## Product / Process Change Notification (PCN)

<p><b>PCN #:</b> PCN_UtRJ45LAN_20220525</p> <p><b>Affected Series:</b> WE-UtRJ45LAN; 7499xxx; S1xxx</p> <p><b>PCN Date:</b> February 25, 2022</p> <p><b>Effective Date:</b> May 25, 2022</p>	<p><b>Change Category:</b></p> <p><input type="checkbox"/> Equipment / Location</p> <p><input type="checkbox"/> General Data</p> <p><input type="checkbox"/> Material</p> <p><input type="checkbox"/> Process</p> <p><input checked="" type="checkbox"/> Product Design</p> <p><input type="checkbox"/> Shipping / Packaging</p> <p><input type="checkbox"/> Supplier</p> <p><input type="checkbox"/> Software</p>
<p><b>Contact:</b> Product Management</p> <p><b>Phone:</b> +49 (0) 7942 - 945 5001</p> <p><b>Fax:</b> +49 (0) 7942 - 945 5179</p> <p><b>E-Mail:</b> pcn.eisos@we-online.com</p>	<p><b>Data Sheet Change:</b></p> <p><input checked="" type="checkbox"/> Yes      <input type="checkbox"/> No</p> <p><b>Attachment:</b></p> <p><input type="checkbox"/> Yes      <input checked="" type="checkbox"/> No</p>

**Description and purpose of change:**

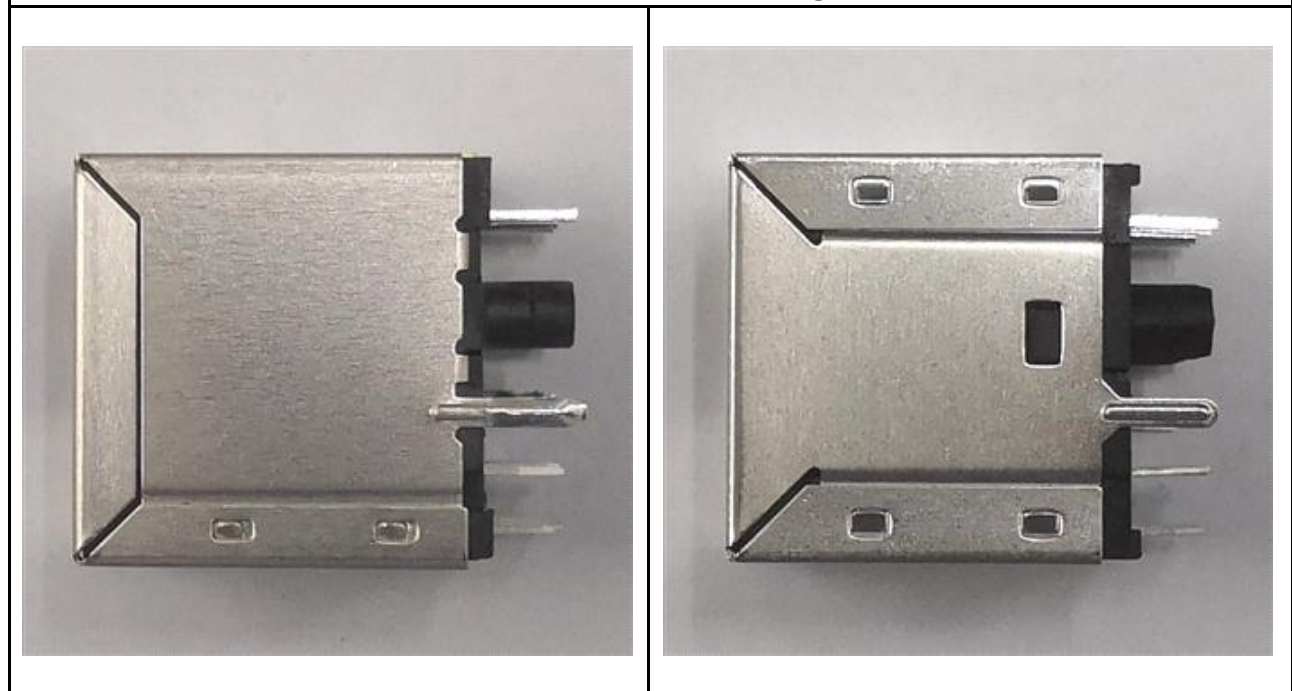
**Above:** The shield of the RJ45 is covering the LEDs.

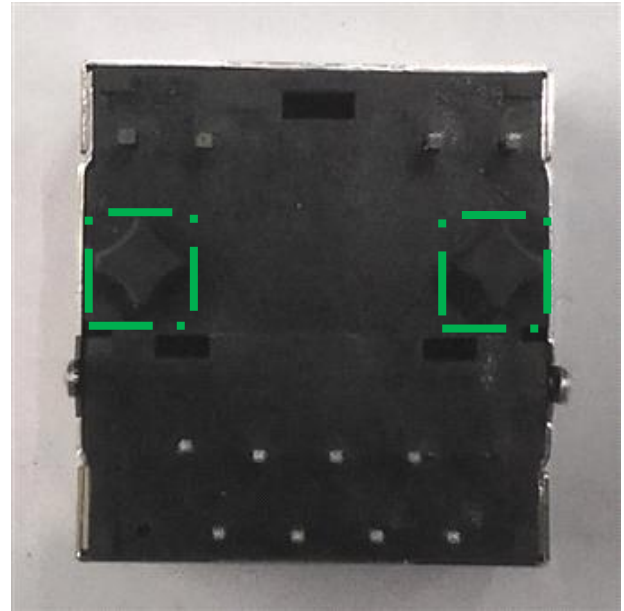
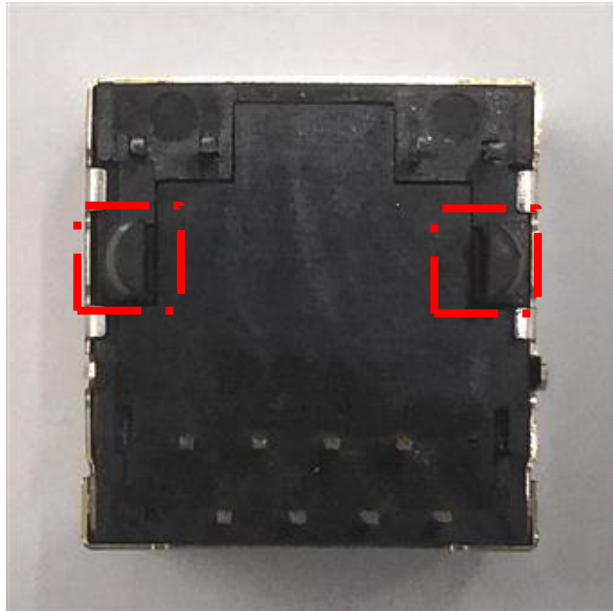
**Above:** The RJ45 shield will be closed on both sides while assembly to make the assembly easier.

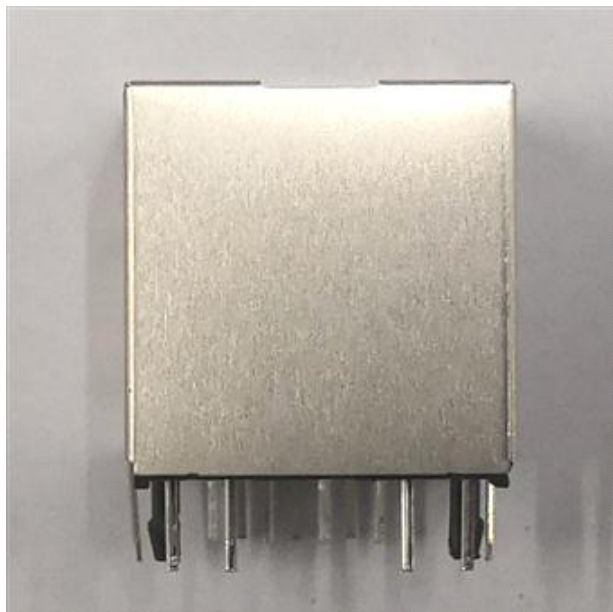
**Above:** The bottom plastic pins are even more robust after change.

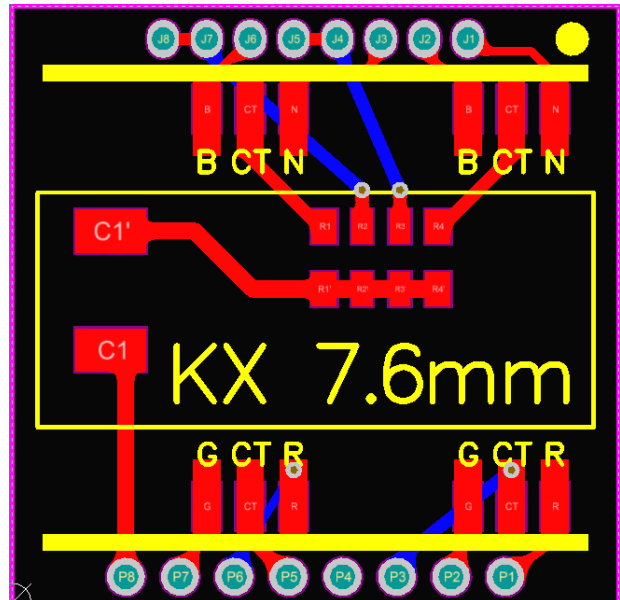
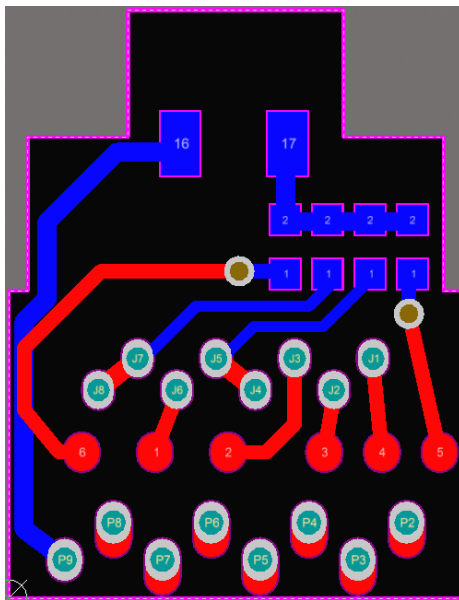
Content	Specification
Transformer core (T1)	3.43x1.78x2.06 mm
CMC core (T2)	2.64x1.40x1.27 mm
Wire	0.10mm QPN
Turns	12T+10T

**Coils are manually soldered**

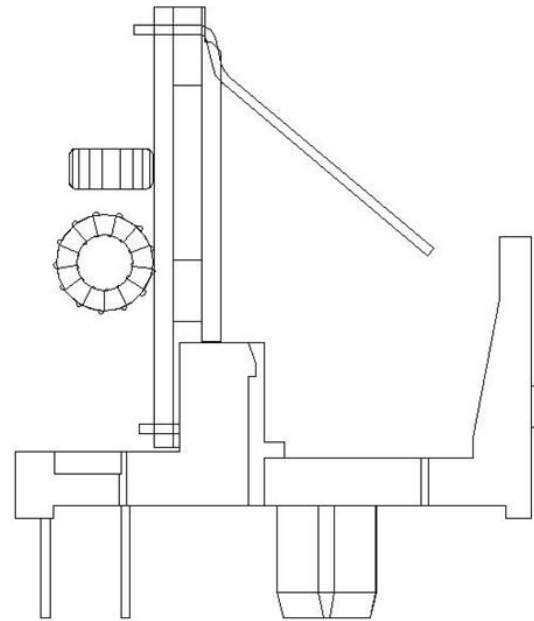
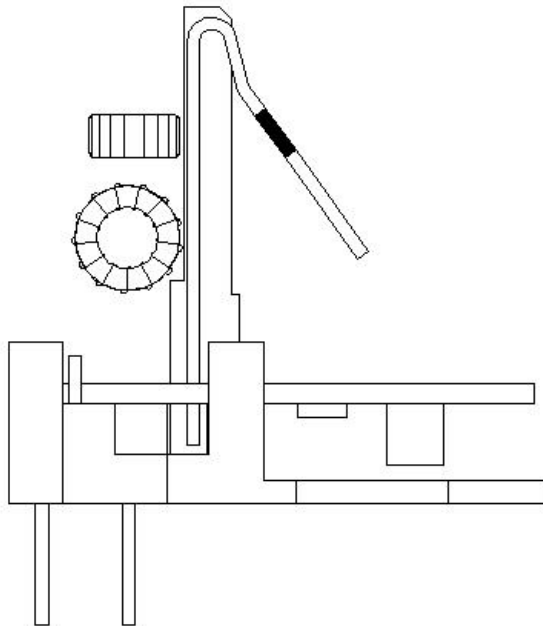
Content	Specification
Transformer core (T1)	3.05x1.78x2.06 mm
CMC core (T2)	2.64x1.40x1.27 mm
Wire	0.09mm QPN
Turns	14T+10T

**Coils are welded by automatic spot welding**

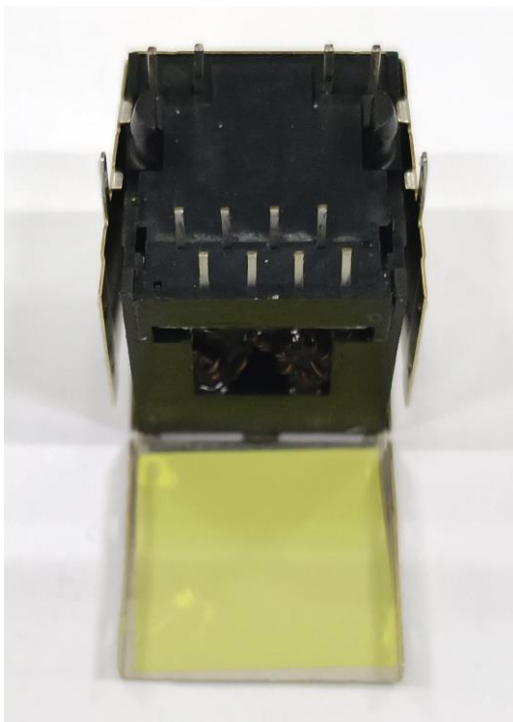
**Above:** Improved positioning of the PCB.

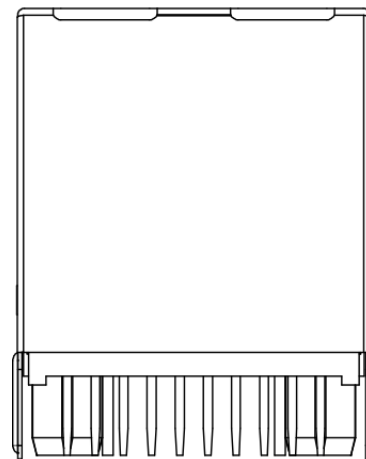
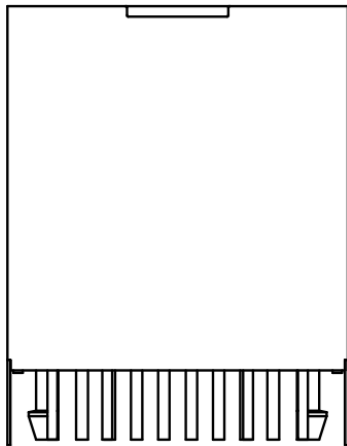
**Above:** Using a plastic plate instead of a thin tape to separate cores from Shielding.

**Above:** The pin shape will change from straight to sharp, to ensure easier assembly.

7499010129:

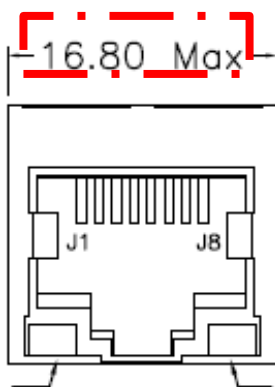
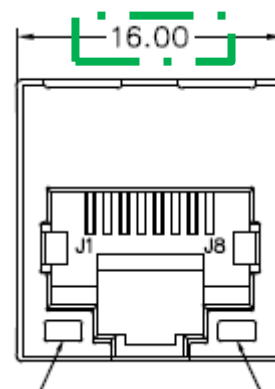
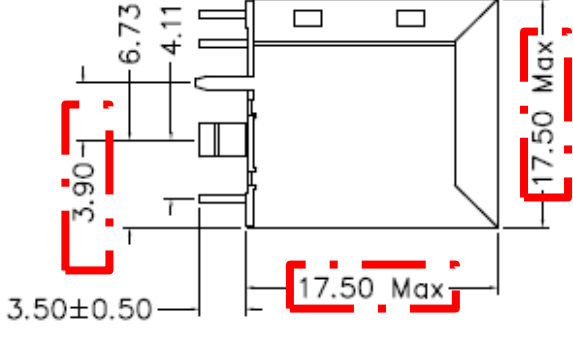
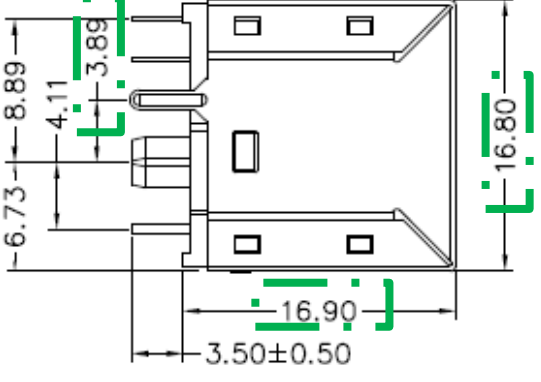
<p>Dielectric Rating: 1500 Vrms</p>	<p>Dielectric Rating: 2250 VDC</p>
<p>Return Loss:        1 – 10 MHz        10 – 30 MHz        30 – 60 MHz        60 – 80 MHz</p>	<p>Return Loss:        1 – 30 MHz        30 – 60 MHz        60 – 80 MHz        80 – 100 MHz</p>
<p>Common Mode Rejection:        1 – 100 MHz</p>	<p>Common Mode Rejection:        1 – 30 MHz        30 – 60 MHz        60 – 100 MHz</p>
<p>Crosstalk:        1 – 100 MHz</p>	<p>Crosstalk:        1 – 60 MHz        60 – 100 MHz</p>

74990101210:

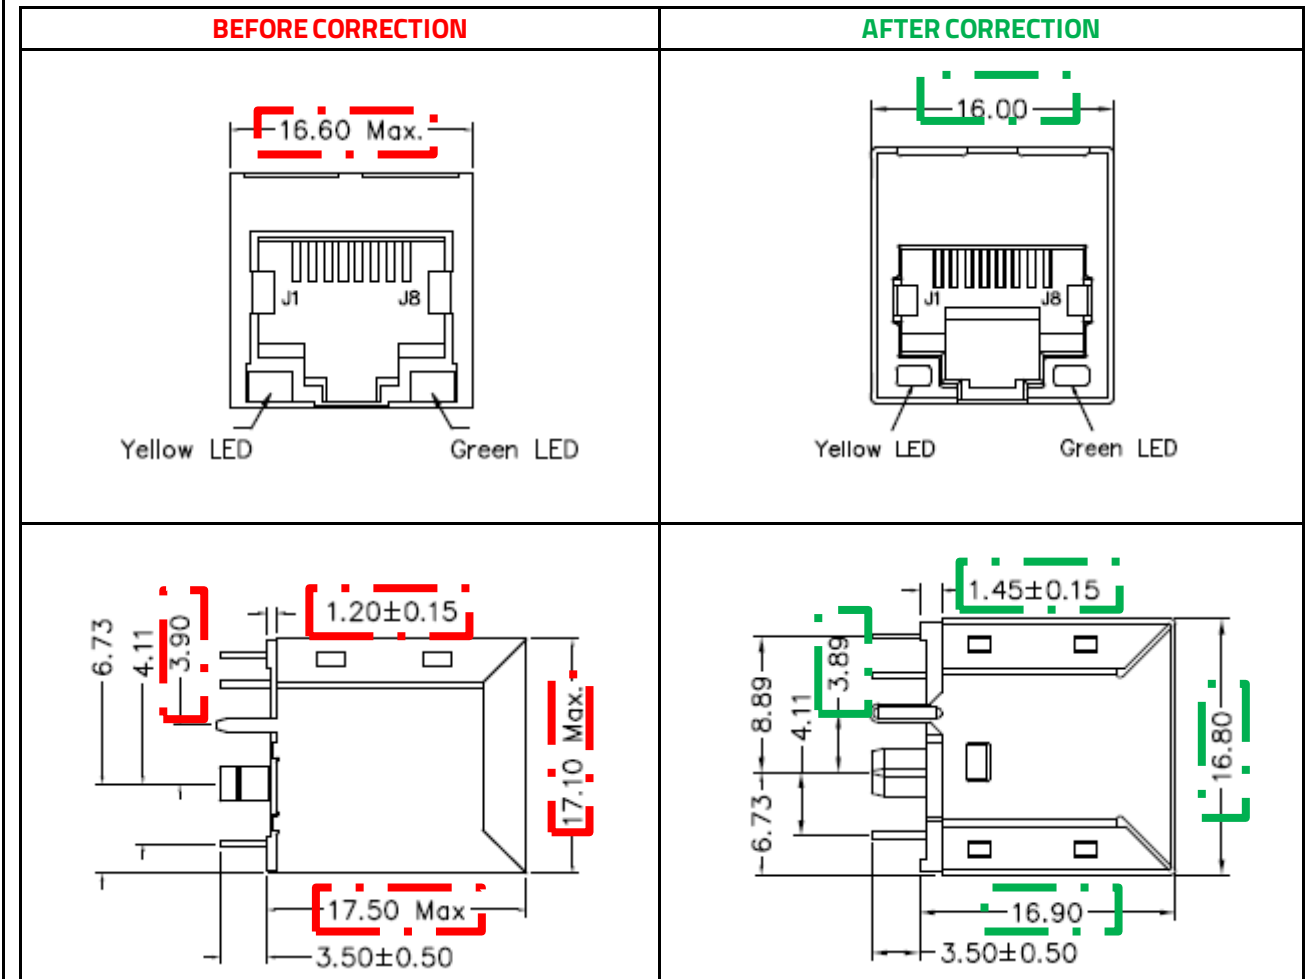
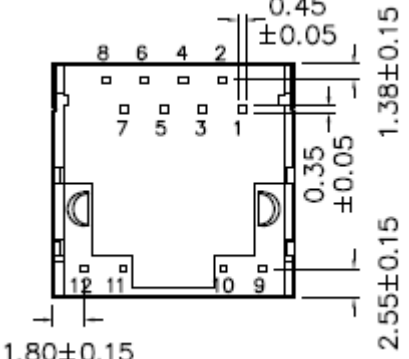
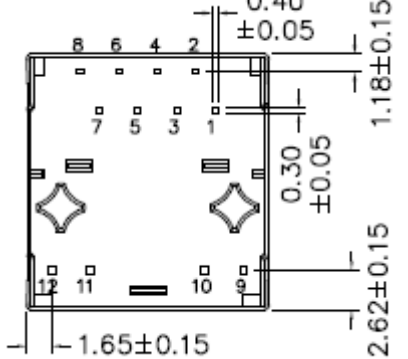
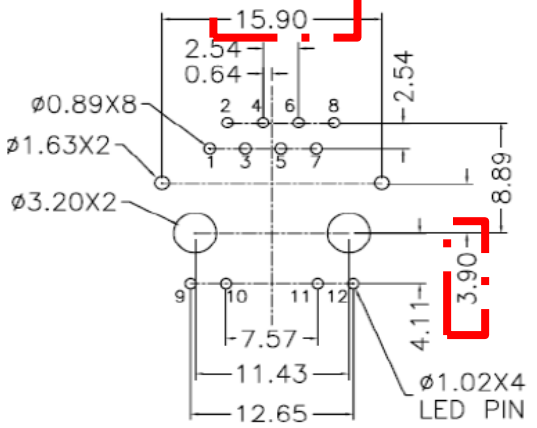
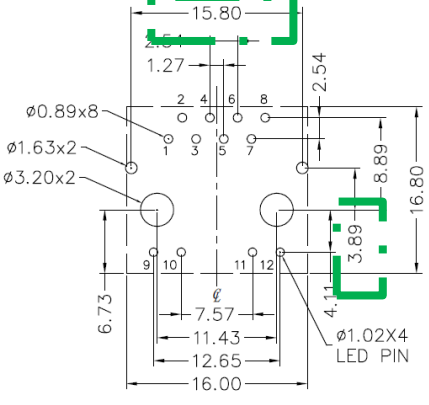
<p>Dielectric Rating: 1500 Vrms</p>	<p>Dielectric Rating: 2250 VDC</p>
<p>Return Loss:              1 – 10 MHz              10 – 30 MHz              30 – 60 MHz              60 – 80 MHz</p>	<p>Return Loss:              1 – 30 MHz              30 – 60 MHz              60 – 80 MHz              80 – 100 MHz</p>
<p>Common Mode Rejection:              1 – 100 MHz</p>	<p>Common Mode Rejection:              1 – 30 MHz              30 – 60 MHz              60 – 100 MHz</p>
<p>Crosstalk:              1 – 100 MHz</p>	<p>Crosstalk:              1 – 60 MHz              60 – 100 MHz</p>
 <p>RECOMMENDED              P.C.PATTERN.COMPONENT SIDE</p>	 <p>RECOMMENDED              P.C.PATTERN.COMPONENT SIDE</p>

74990101241:

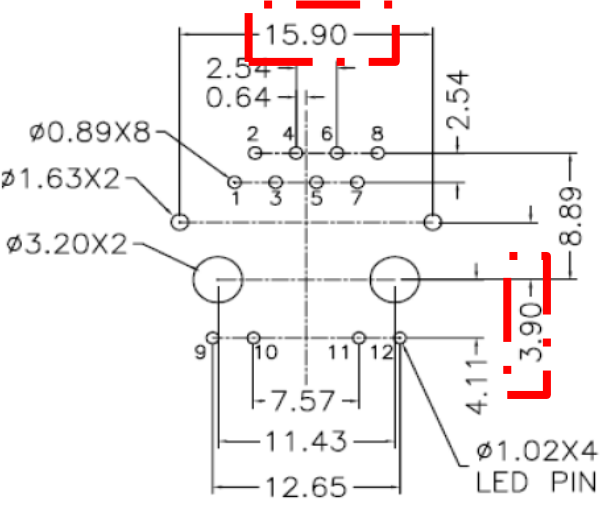
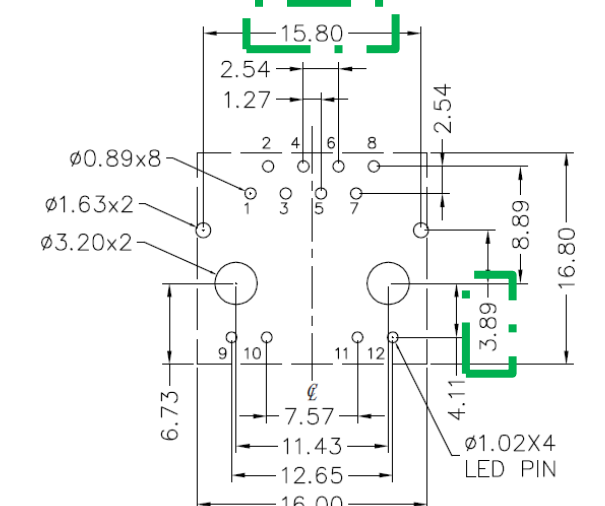
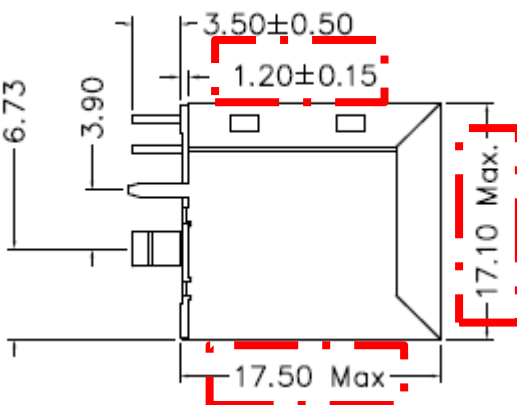
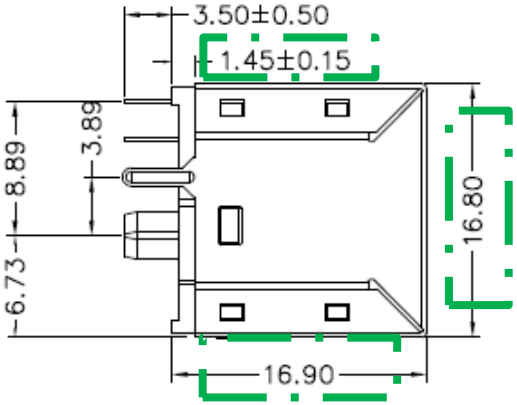
BEFORE CORRECTION	AFTER CORRECTION
 <p>16.80 Max</p> <p>J1 J8</p> <p>Yellow LED Green LED</p>	 <p>16.00</p> <p>J1 J8</p> <p>Yellow LED Green LED</p>
 <p>6.73 4.11 3.90 3.50±0.50</p> <p>17.50 Max 17.50 Max</p>	 <p>8.89 4.11 3.89 3.50±0.50</p> <p>16.80 16.90</p>
 <p>8 6 4 2 7 5 3 1 12 11 10 9</p>	 <p>8 6 4 2 7 5 3 1 12 11 10 9</p>
<p>Dielectric Rating: 1500 Vrms</p>	<p>Dielectric Rating: 2250 VDC</p>

<p>Return Loss:                  1 – 30 MHz                  30 – 45 MHz                  45 – 60 MHz                  60 – 80 MHz</p>	<p>Return Loss:                  1 – 30 MHz                  30 – 60 MHz                  60 – 80 MHz                  80 – 100 MHz</p>
<p>Common Mode Rejection:                  1 – 100 MHz</p>	<p>Common Mode Rejection:                  1 – 30 MHz                  30 – 60 MHz                  60 – 100 MHz</p>
<p>Crosstalk:                  1 – 100 MHz</p>	<p>Crosstalk:                  1 – 60 MHz                  60 – 100 MHz</p>
 <p>RECOMMENDED                  P.C.PATTERN.COMPONENT SIDE</p>	 <p>RECOMMENDED                  P.C.PATTERN.COMPONENT SIDE</p>

S16100131:	
BEFORE CORRECTION	AFTER CORRECTION

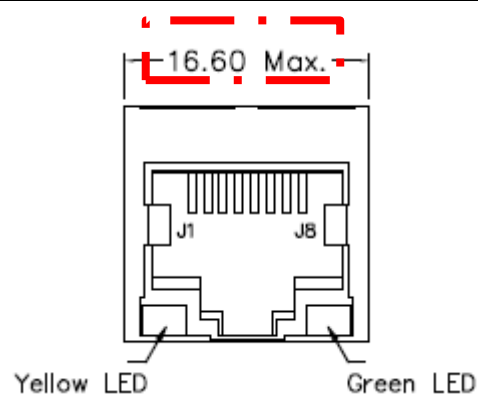
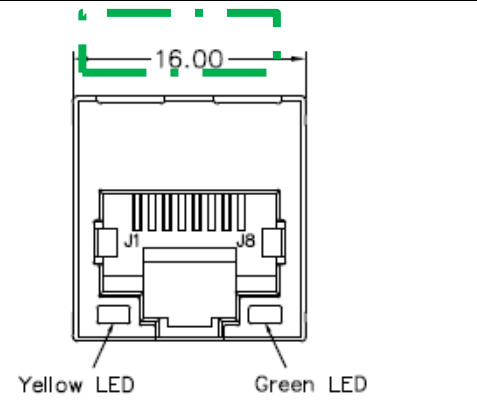
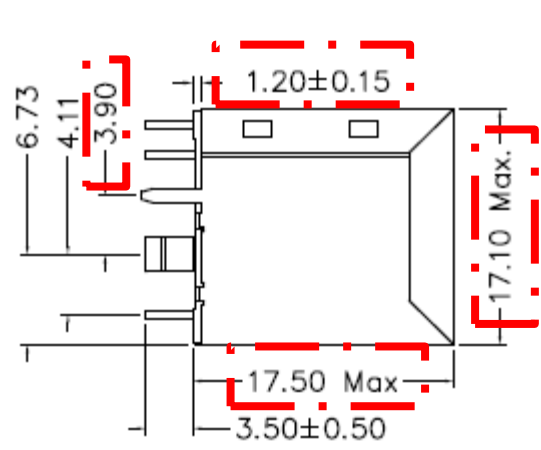
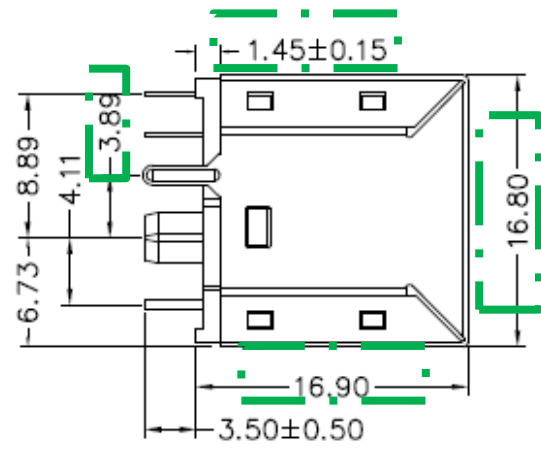
Dielectric Rating: 1500 Vrms	Dielectric Rating: 2250 VDC

Return Loss: 1 – 10 MHz 10 – 30 MHz 30 – 60 MHz 60 – 80 MHz	Return Loss: 1 – 30 MHz 30 – 60 MHz 60 – 80 MHz 80 – 100 MHz
Common Mode Rejection: 1 – 100 MHz	Common Mode Rejection: 1 – 30 MHz 30 – 60 MHz 60 – 100 MHz
Crosstalk: 1 – 100 MHz	Crosstalk: 1 – 60 MHz 60 – 100 MHz

S17100061:

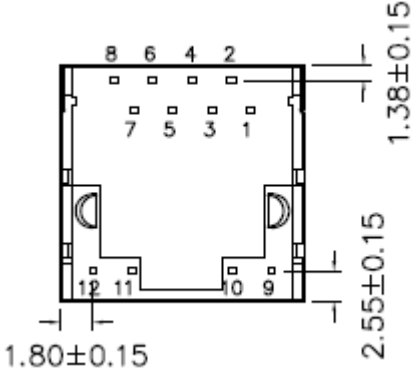
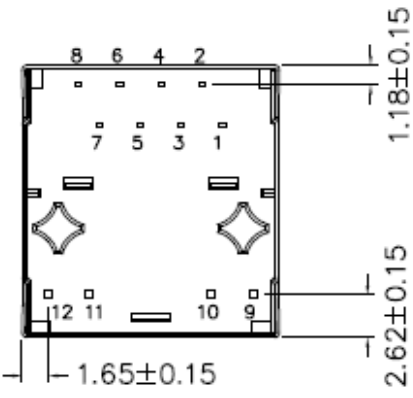
BEFORE CORRECTION	AFTER CORRECTION
 <p style="text-align: center;">16.60 Max.</p> <p style="text-align: center;">Yellow LED      Green LED</p>	 <p style="text-align: center;">16.00</p> <p style="text-align: center;">Yellow LED      Green LED</p>
 <p style="text-align: center;">6.73 4.11 3.90 1.20±0.15 17.10 Max. 17.50 Max. 3.50±0.50</p>	 <p style="text-align: center;">6.73 8.89 4.11 3.89 1.45±0.15 16.80 16.90 3.50±0.50</p>

<p>Common Mode Rejection:          1 – 100 MHz</p>	<p>Common Mode Rejection:          1 – 30 MHz          30 – 60 MHz          60 – 100 MHz</p>
<p>Crosstalk:          1 – 100 MHz</p>	<p>Crosstalk:          1 – 60 MHz          60 – 100 MHz</p>
<p><b>Reliability / Qualification Summary:</b>          Thermal Shock – MIL-STD-202-107          Vibration – MIL-STD-202-204          Mating &amp; Un-mating – EIA-364-13D          Durability – EIA-364-09C          Moisture Resistance – MIL-STD-202-106</p>
